ACCESSION NBR:8312300049 DOC.DATE: 83/12/22 NOTARIZED: NO DOCKET #
 FACIL:50-335 St. Lucie Plant, Unit 1, Florida Power & Light Co. 05000335
 AUTH.NAME AUTHOR AFFILIATION
 WILLIAMS,J.W. Florida Power & Light Co.
 RECIP.NAME RECIPIENT AFFILIATION
 EISENHUT,D.G. Division of Licensing

SUBJECT: Provides info requested re seized rotor event, per 831107
 telcon, Graphs encl. Info suppls analysis contained in 820831
 submittal.

Re: St. Lucie Unit No. 1
Docket No. 50-335
Seized Rotor Event
Additional Information Request

FIGURE
 1

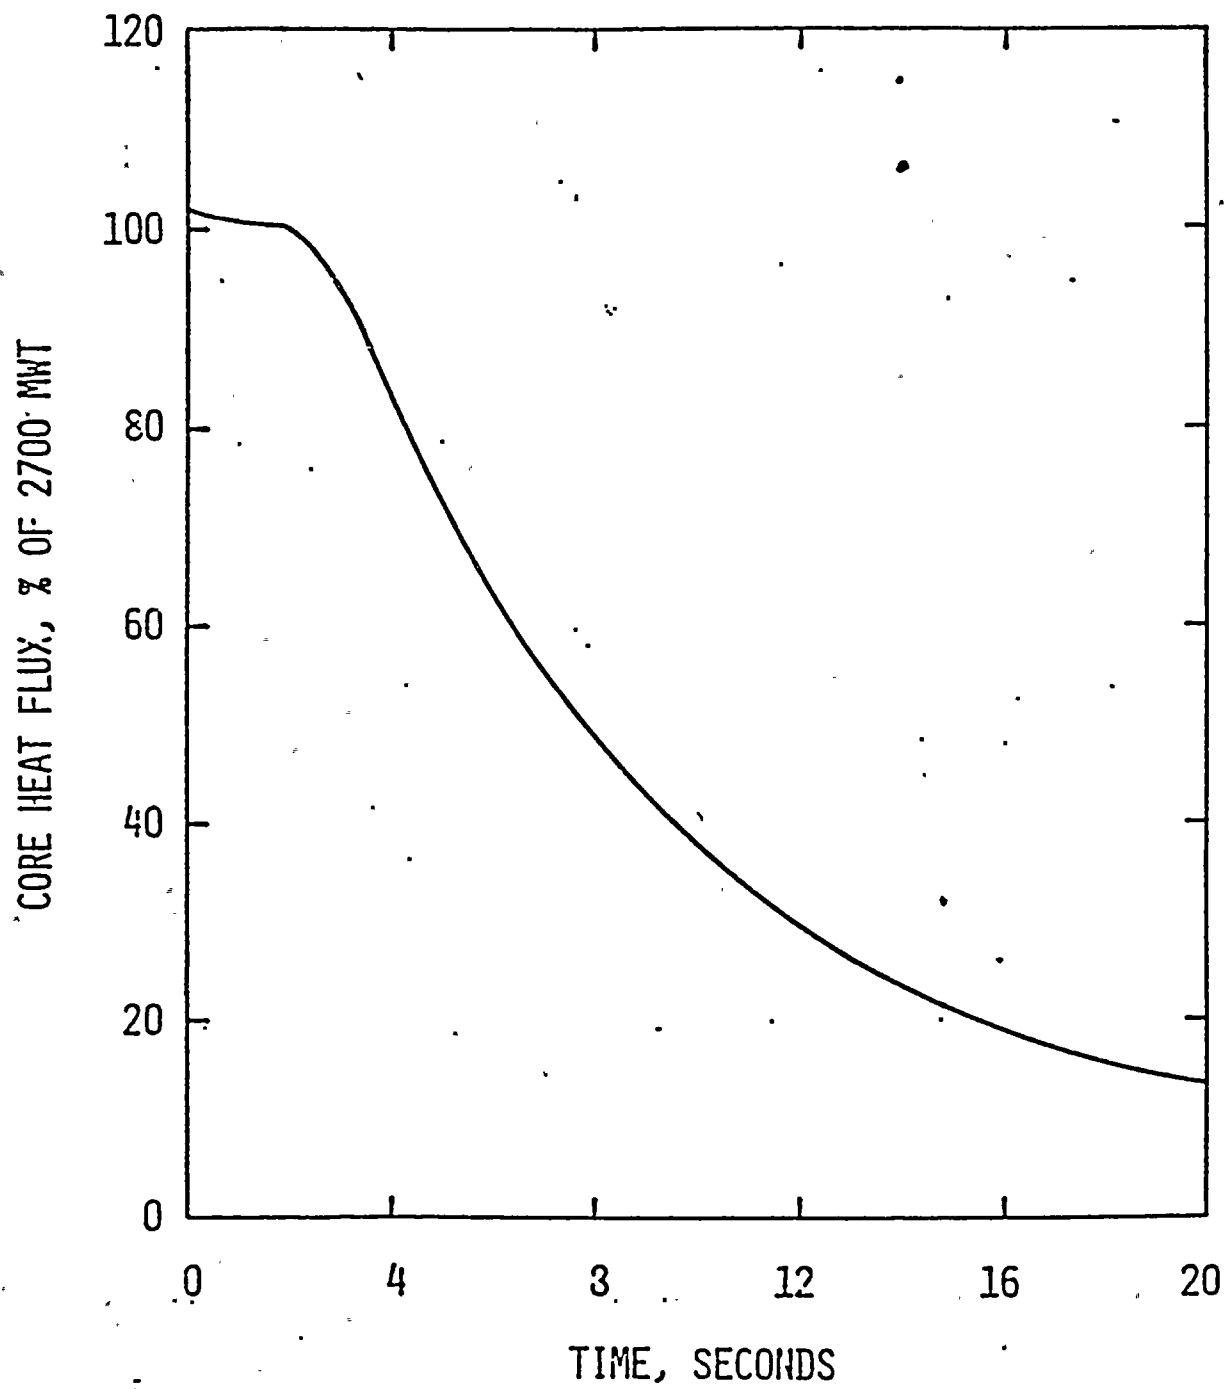
NRC Request : Can additional graphs of the important parameters be supplied with a finer time scale to show details in the early seconds ?

Answer : . Additional graphs are attached.

SEIZED ROTOR WITH LOSS OF AC AND STUCK OPEN ADV
 CORE POWER VS TIME
